## **Addendum #2**

### **Bid Opportunity: 22-7352-RFT - Central Public School - Accessibility, HVAC & Window Upgrades** **Closing Date: Tuesday, January 17, 2023 2:00 PM**

## ADDENDUM 01

**SCHEDULES, LEGEND AND KEY PLAN**

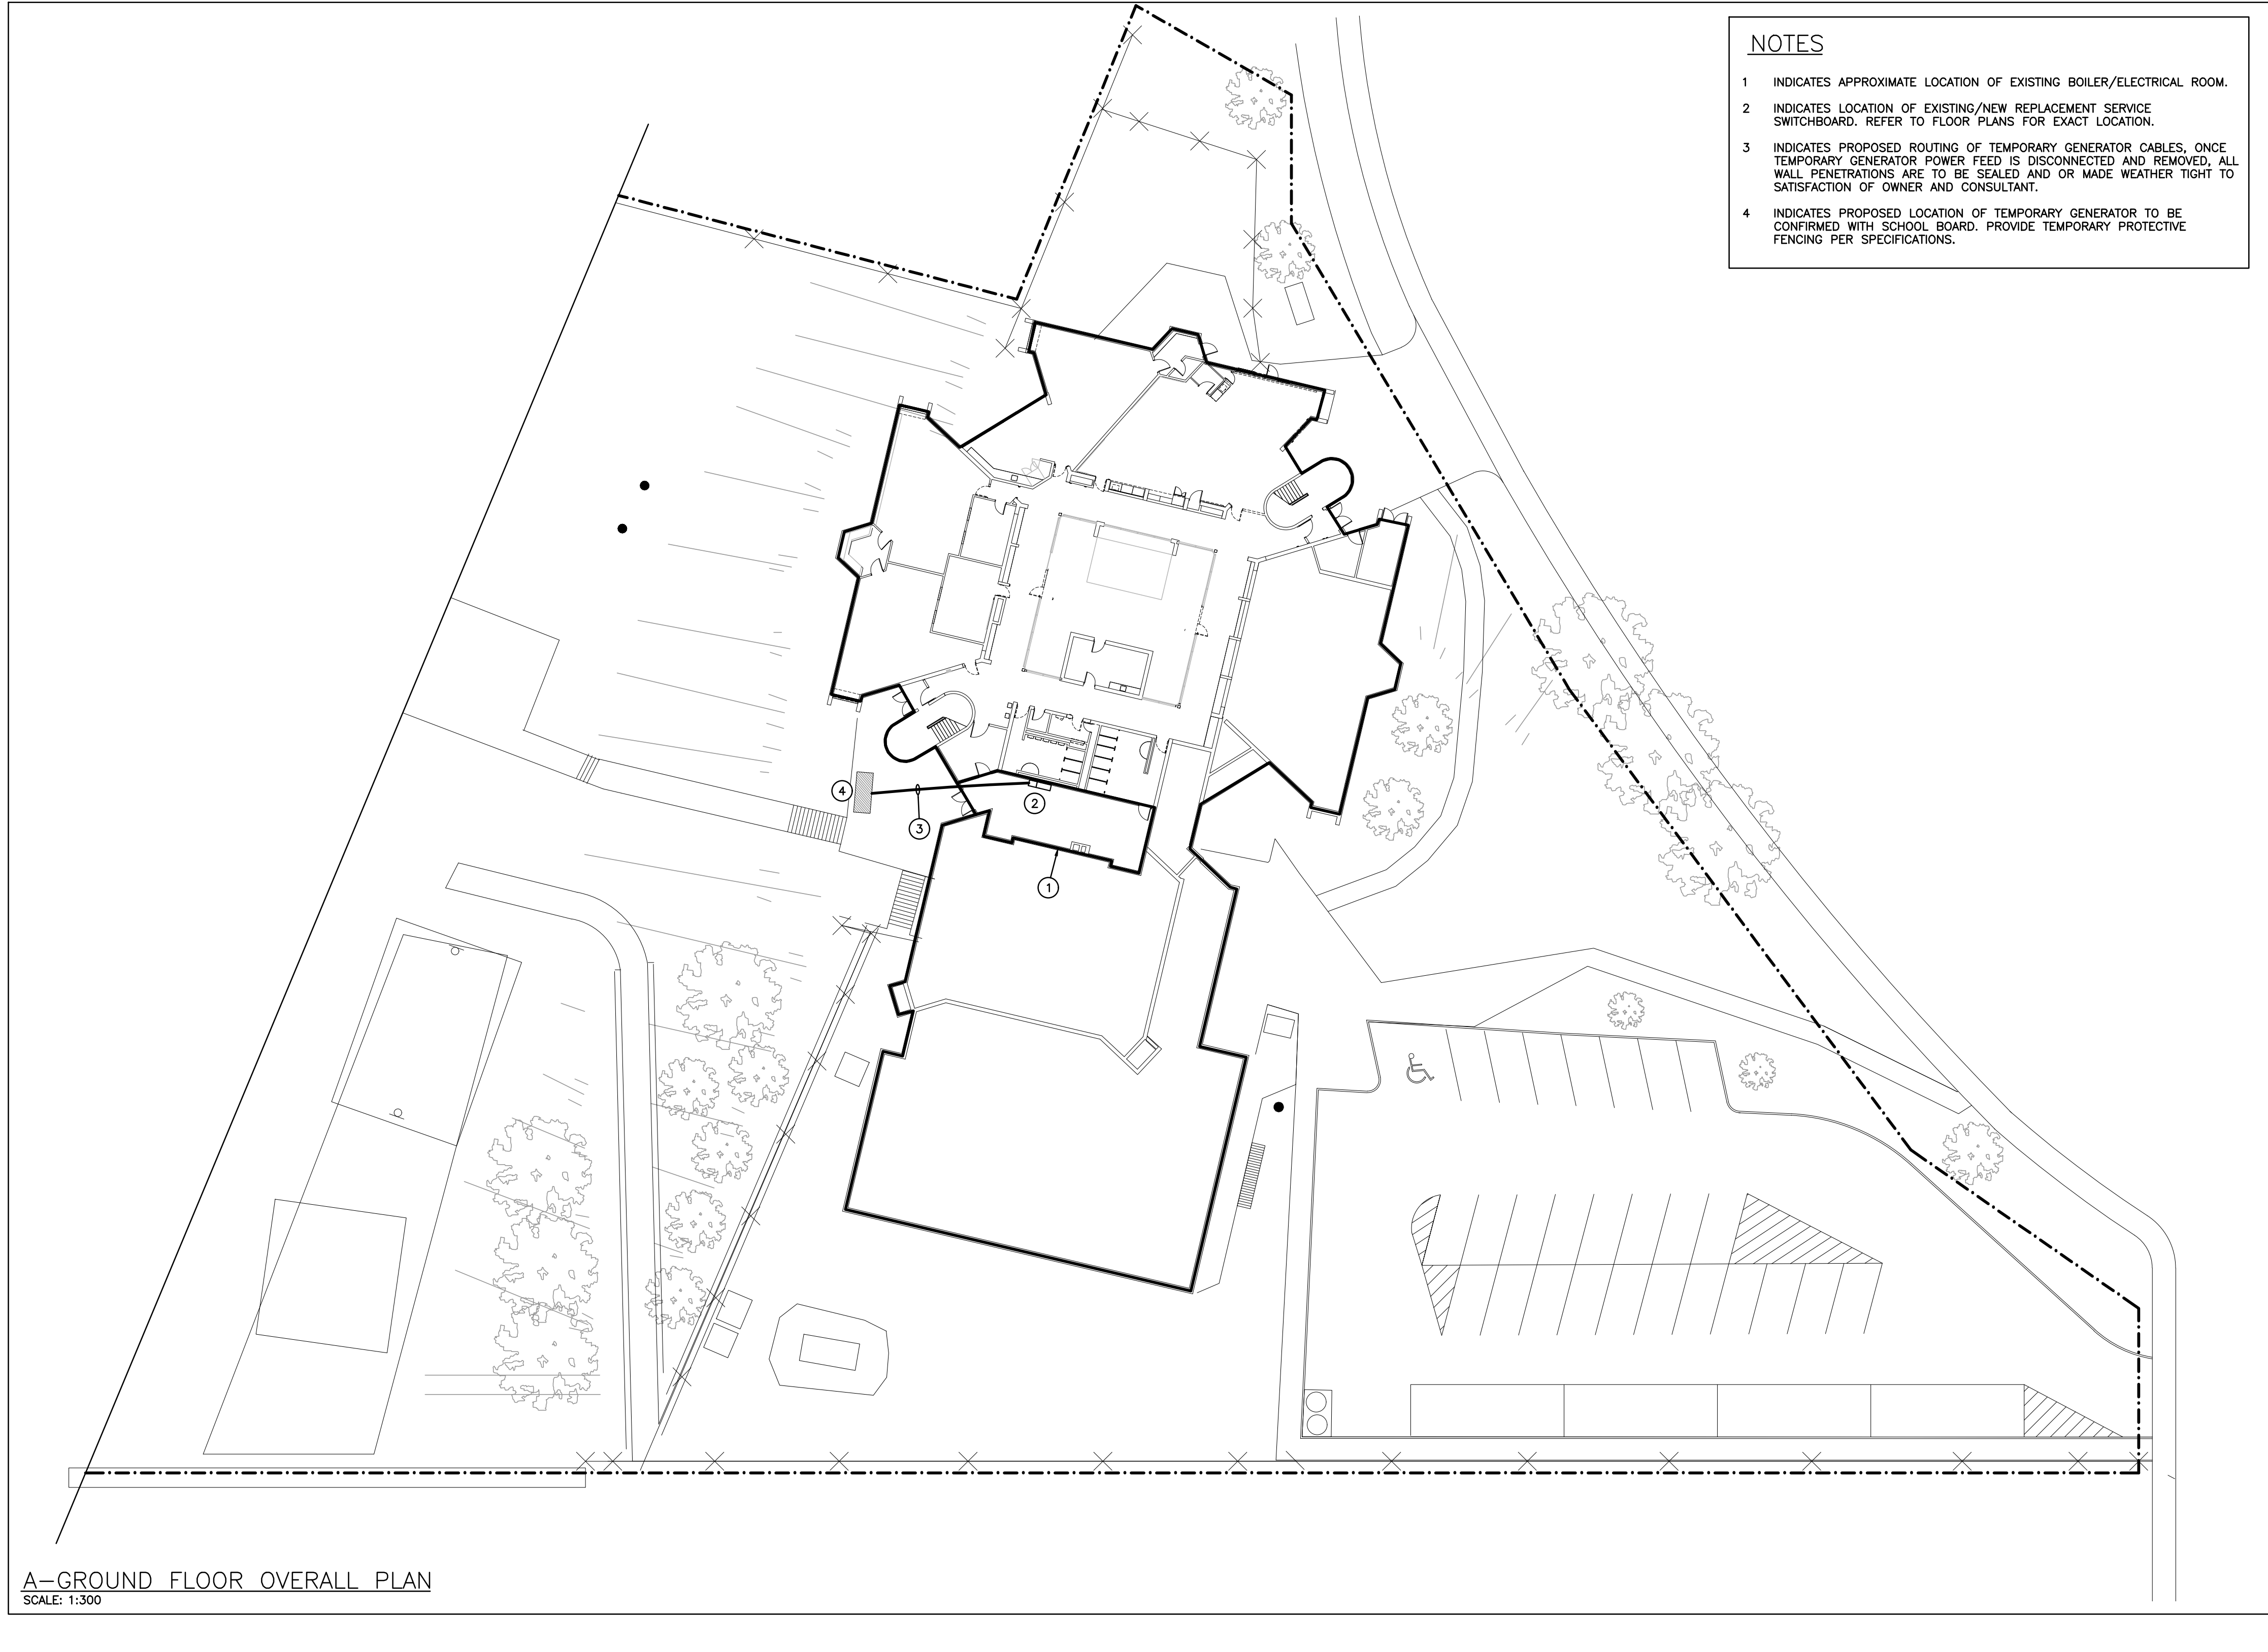
- .1 In the light fixture schedule the following updates have been made as per attached re-issued drawing E01:
1. Type L1 – Signify cat. # has been revised.
  2. Type L2 – Signify cat. # revised to Liteline.
  3. Type L3 – Signify cat. # revised to Liteline.
  4. Type L6 – Lightolier and Halo cat. Numbers added and track length shown in description.
  5. Emerg Battery – Aimlite cat. # revised.
